MEMORANDUM

RE: ZP 14-0884 CA/MA 247-249 Pearl Street

Request: Conditional Use/Major Impact review of proposed redevelopment to include three story residential building with 29 residential units and surface parking to the east and south.

L1.0

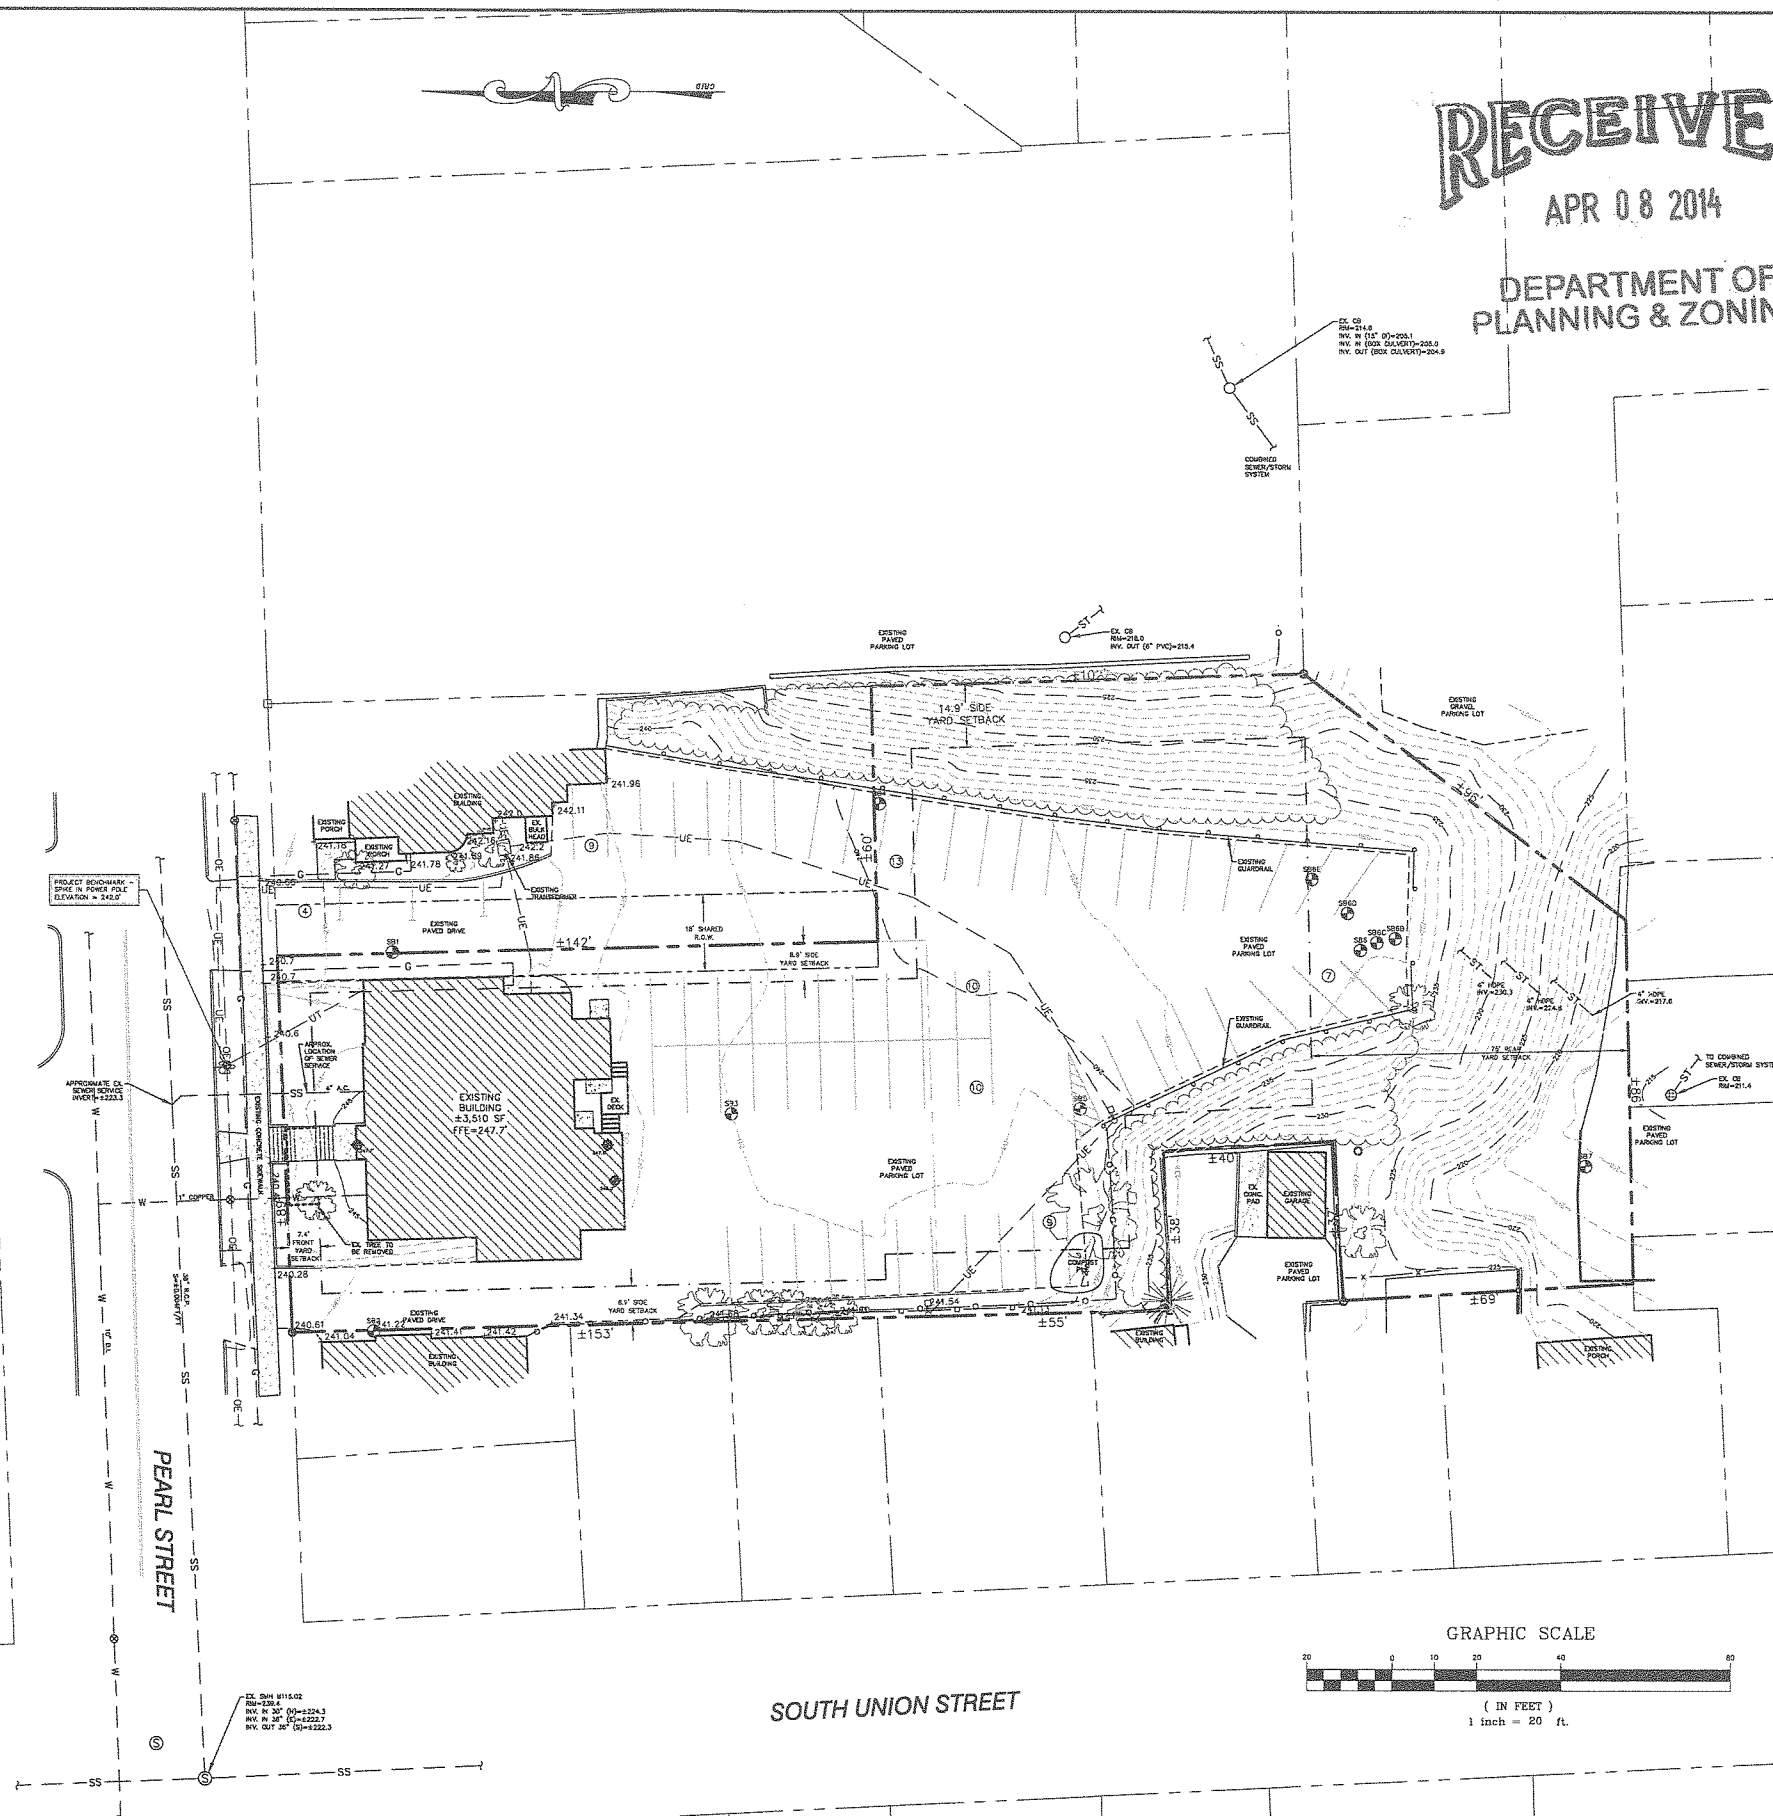
A Planting plan has been submitted (L1.0) that defines new landscaping along portions of the westerly property line, as well as 5 White Pine and an elm tree along the southerly portion of the lot. Two specimen trees are articulated along the walkway (Princeton American Elm) although it is supposed that these are not intended to provide screening but beauty. They will likely be used to meet the requirement for parking lot shading. See Sec. _____, below.

The plan will be required to provide 8 trees meeting the above specified minimum caliper to meet the shading standard ($41 / 5 = 8.2$.) A landscaping plan has been submitted, with 8-9 new trees proposed.

10. Eight trees, of a caliber of 2 ½-3" will be required as part of the planting plan, to meet the parking lot shading requirement of Section 6.2.2. (1). *All new shade trees shall be of a species appropriate for such planting environments, expected to provide a mature canopy of no less than 25-feet in diameter, and selected from an approved list maintained by the city arborist.*

DEPARTMENT OF
PLANNING & ZONING
SHADOW STUDIES

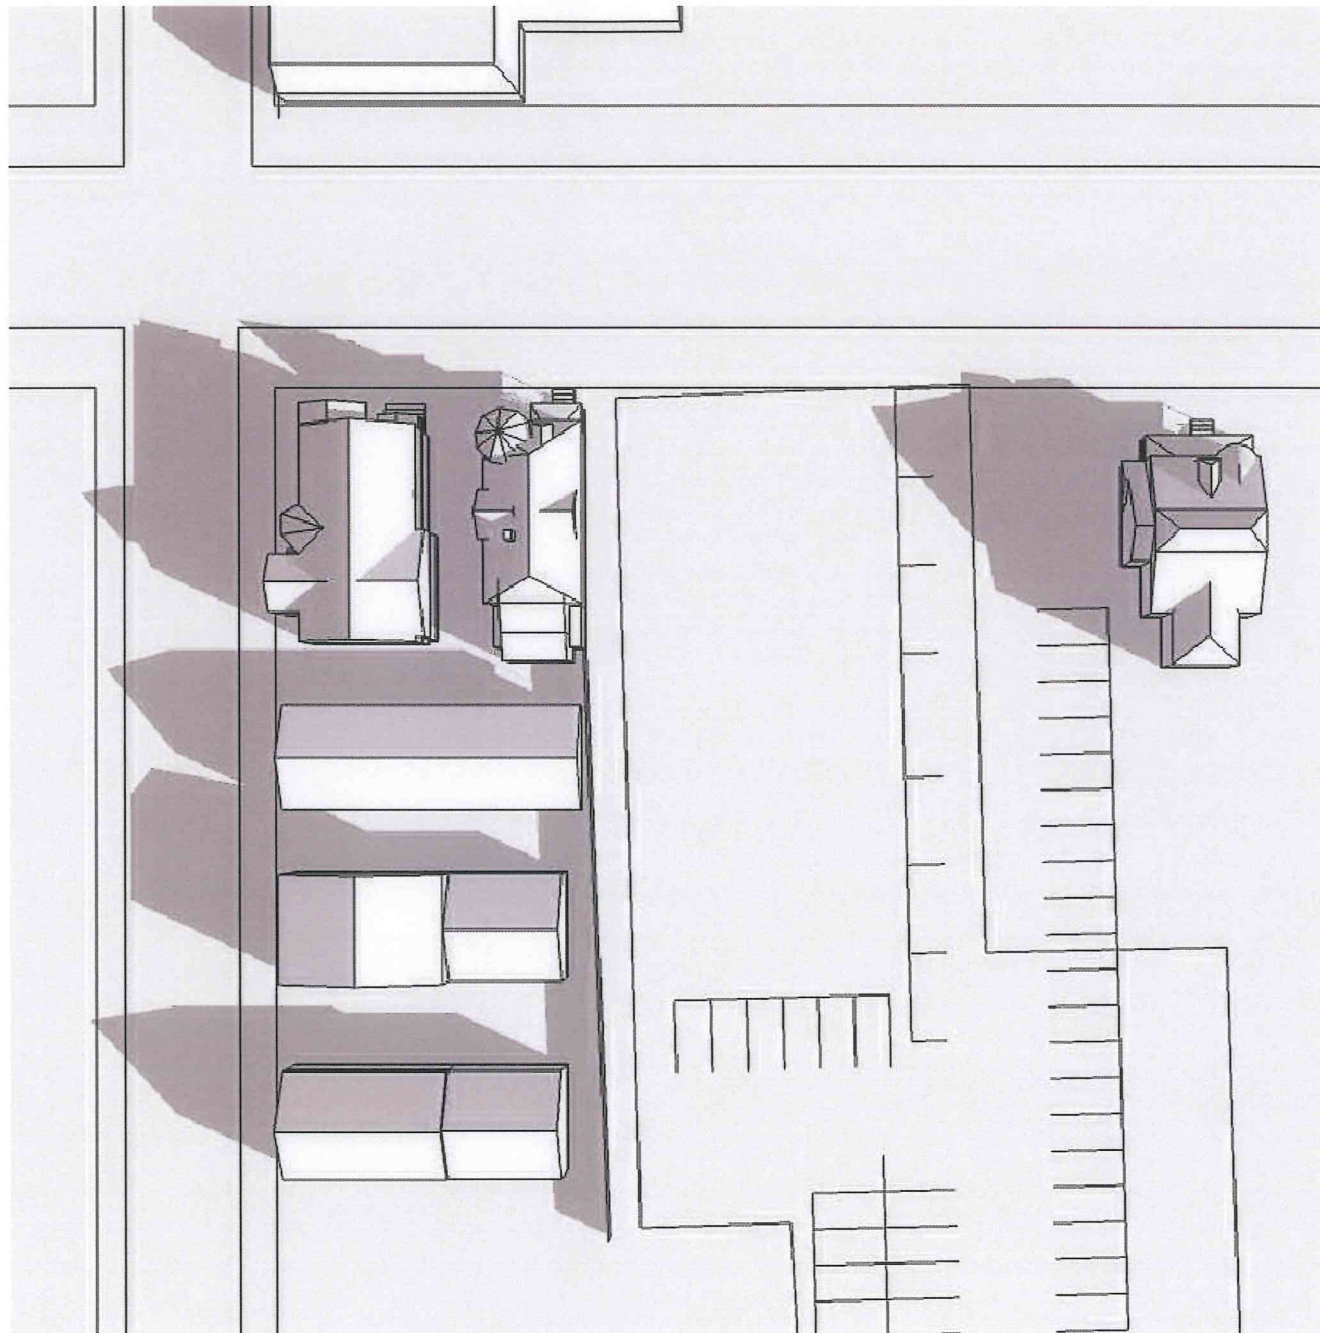
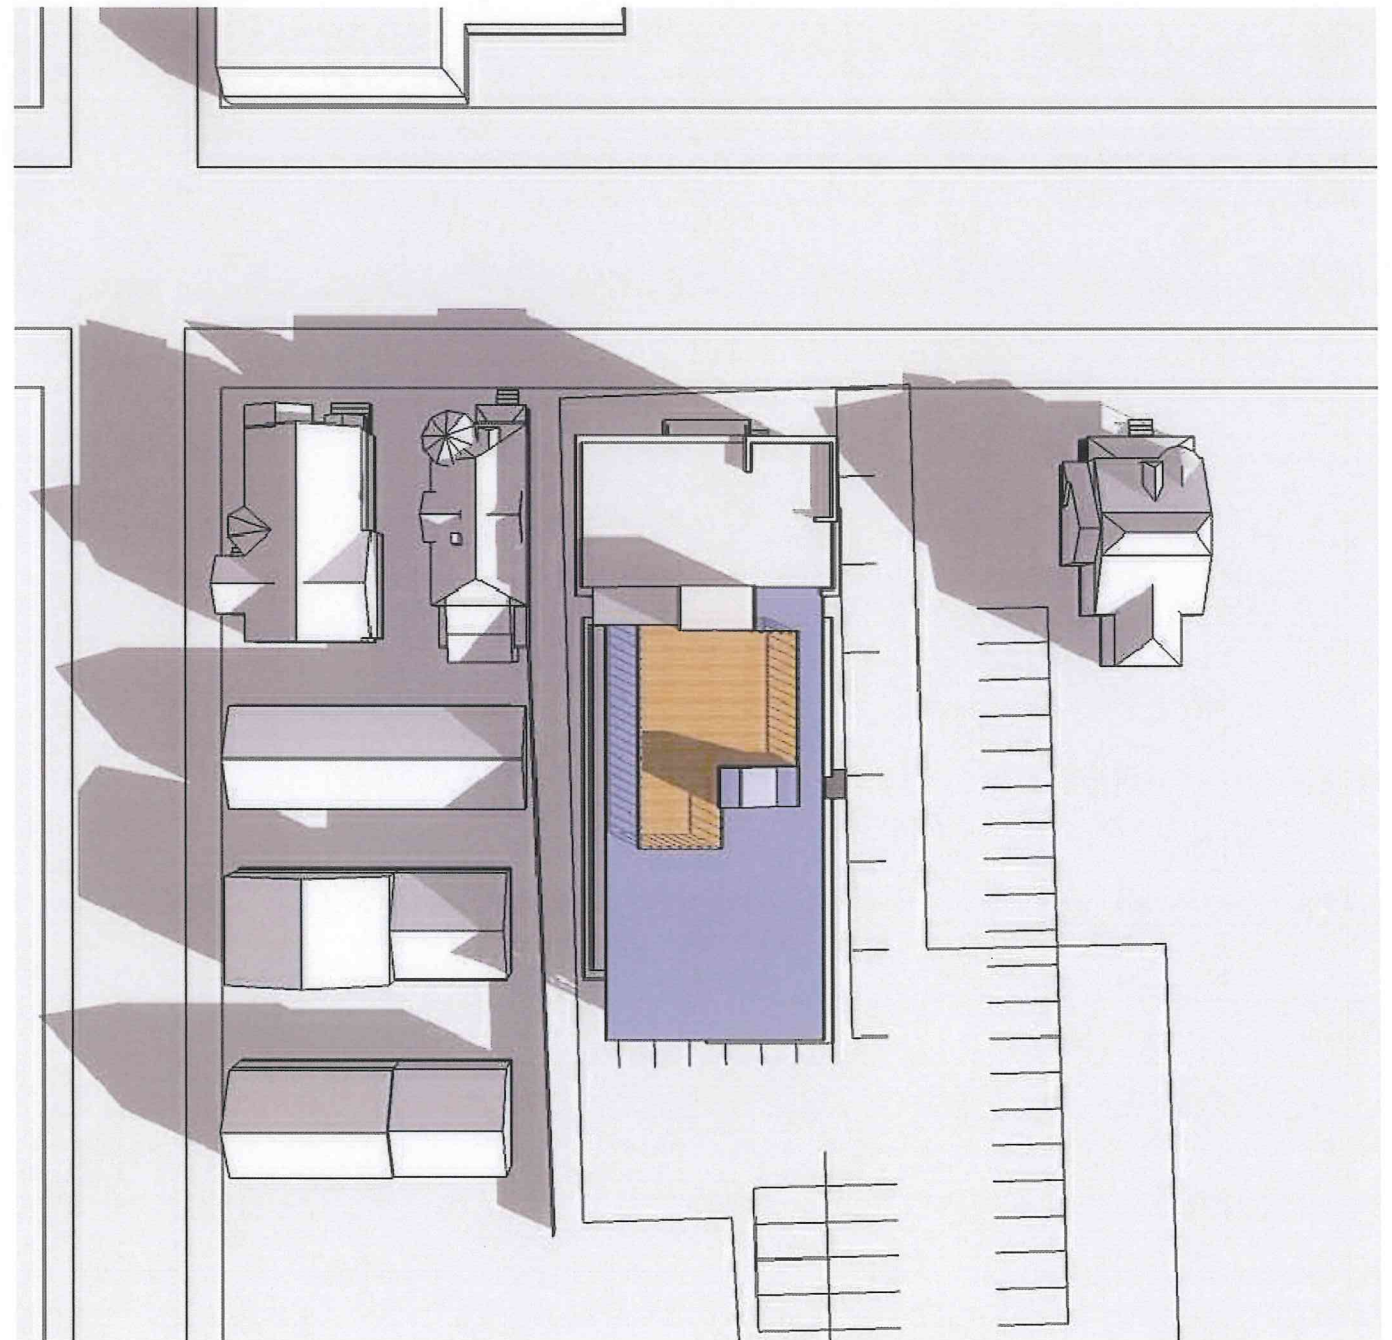
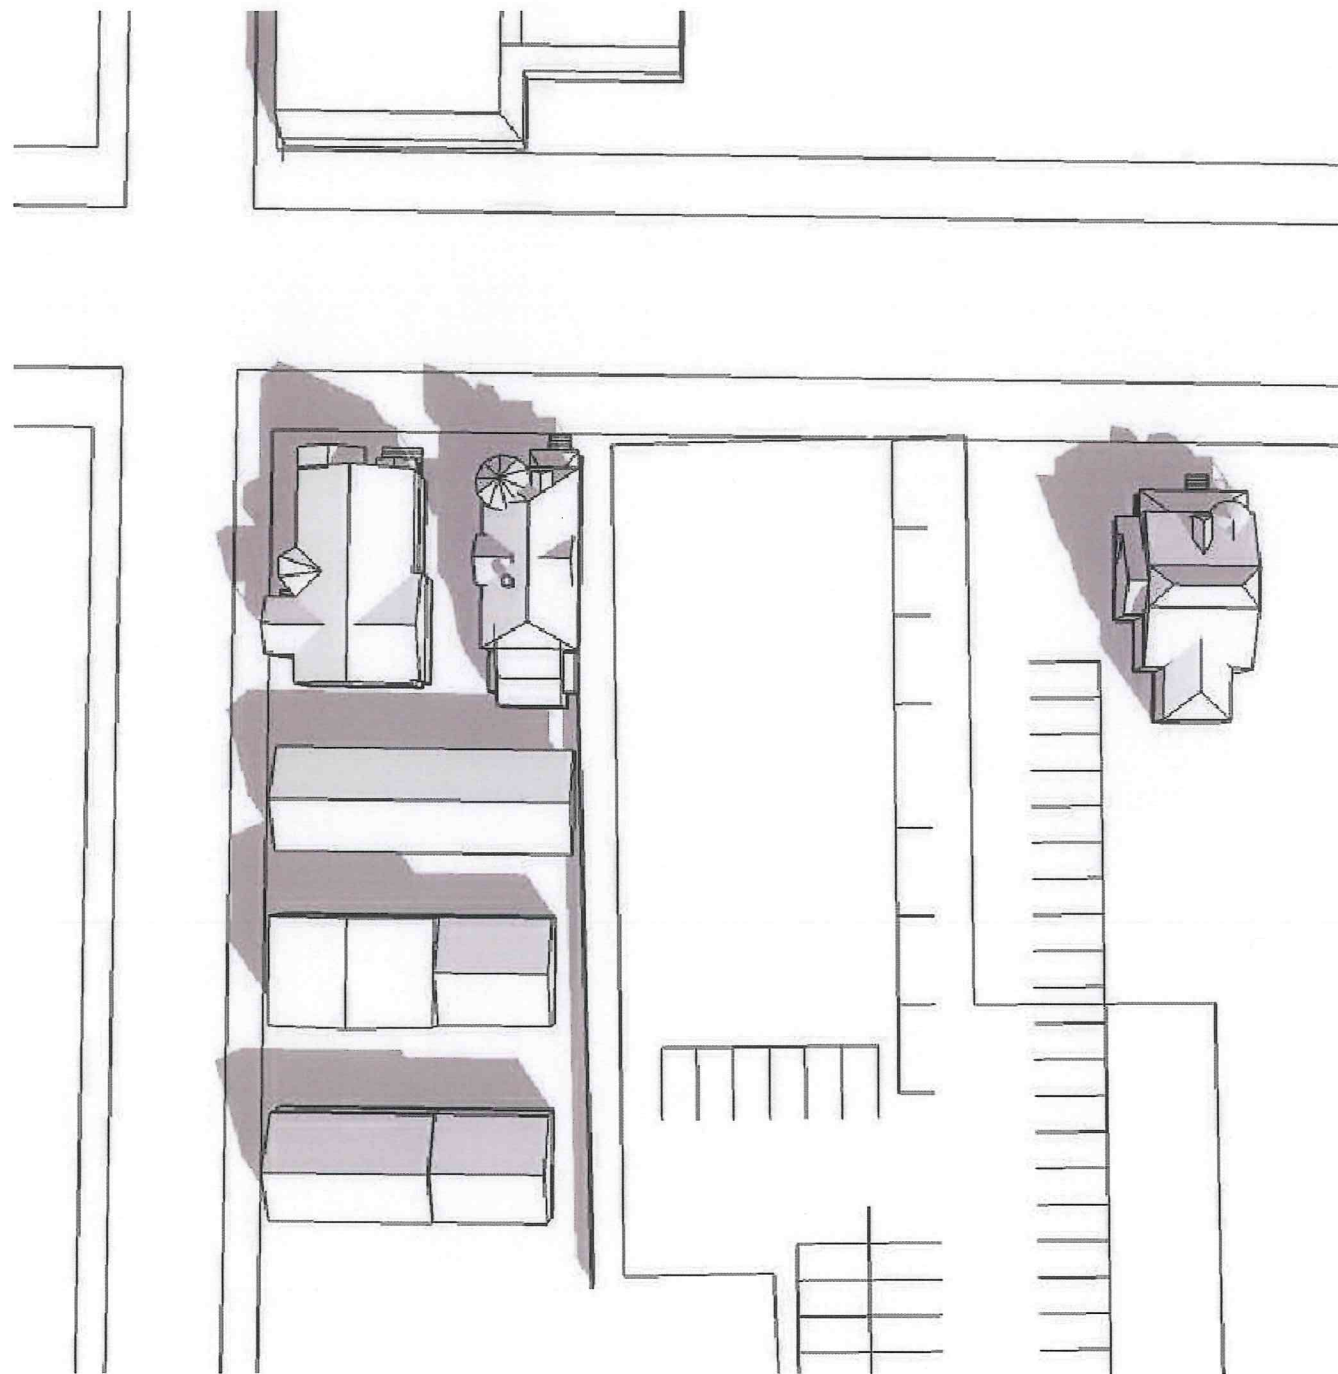
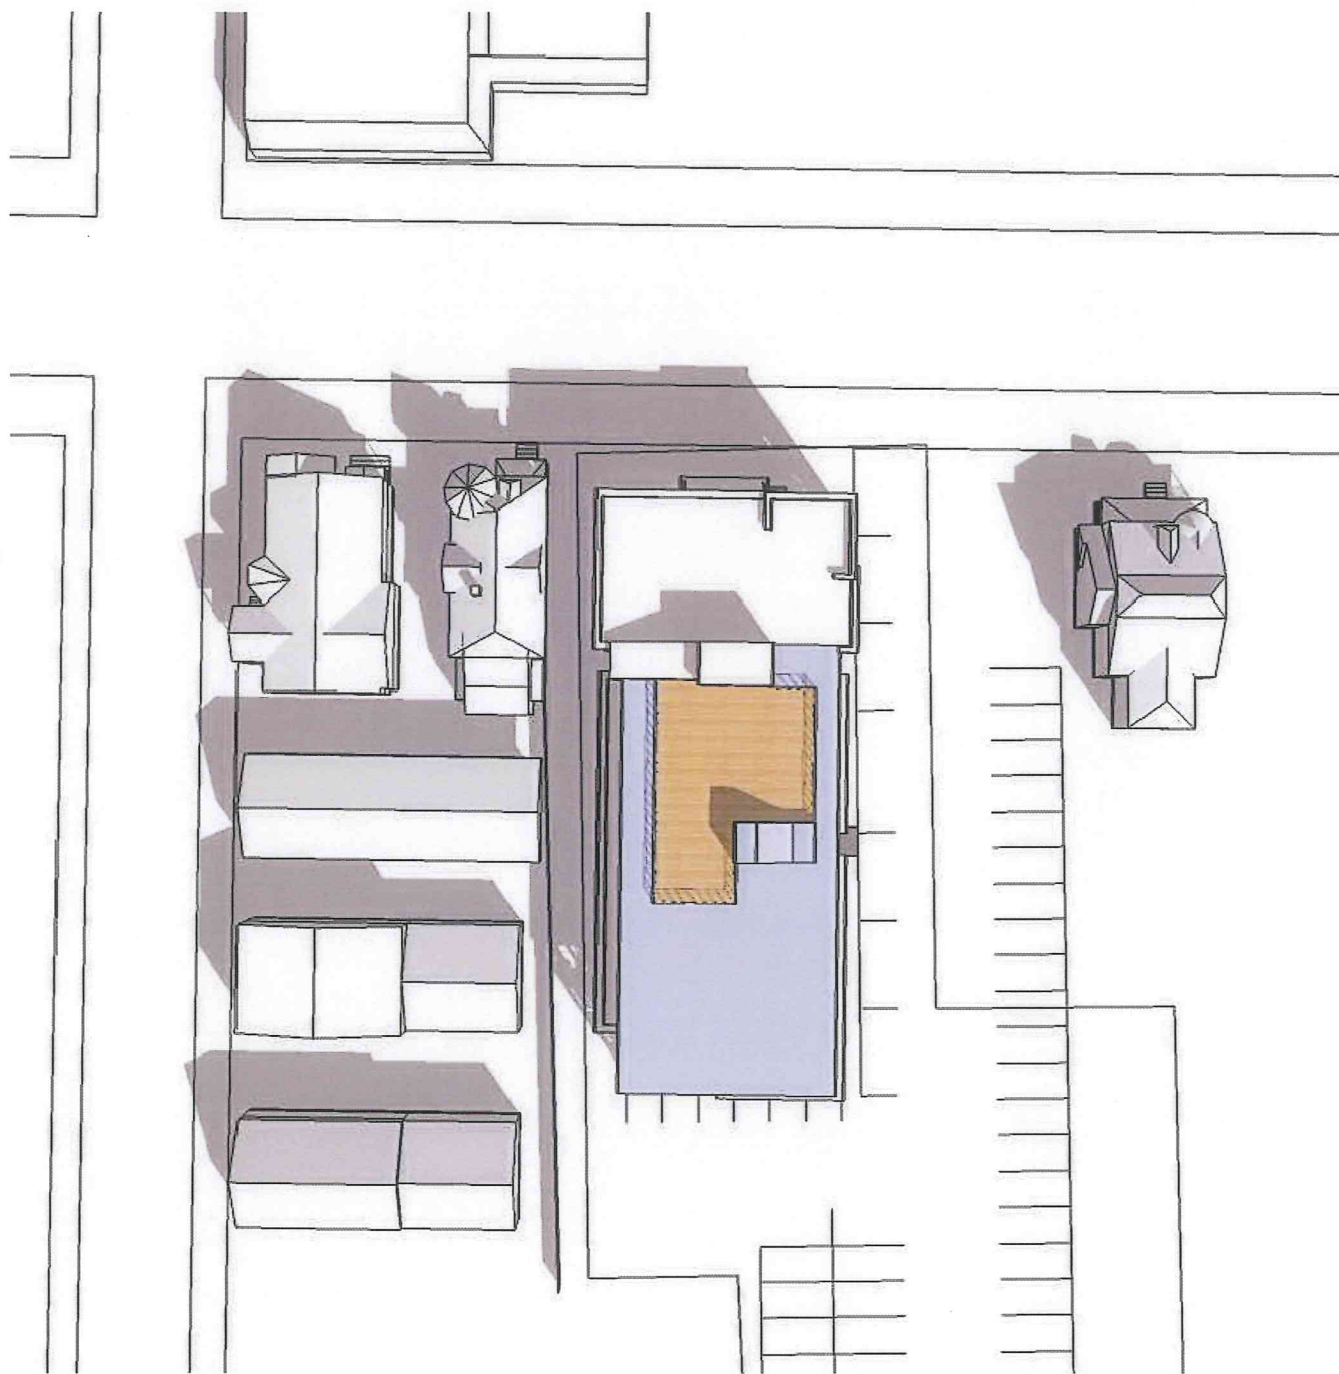
A shading plan has been submitted. Limited shading will be experienced by South Union Street abutters at the autumnal equinox; impacts subsiding by 10:00 am. **Affirmative finding.**

Shade impacts are not anticipated to be a problem, as the most egregious period in Burlington would be the autumnal equinox. The shadowcast is illustrated in the attached shading plan. Solar energy is encouraged.
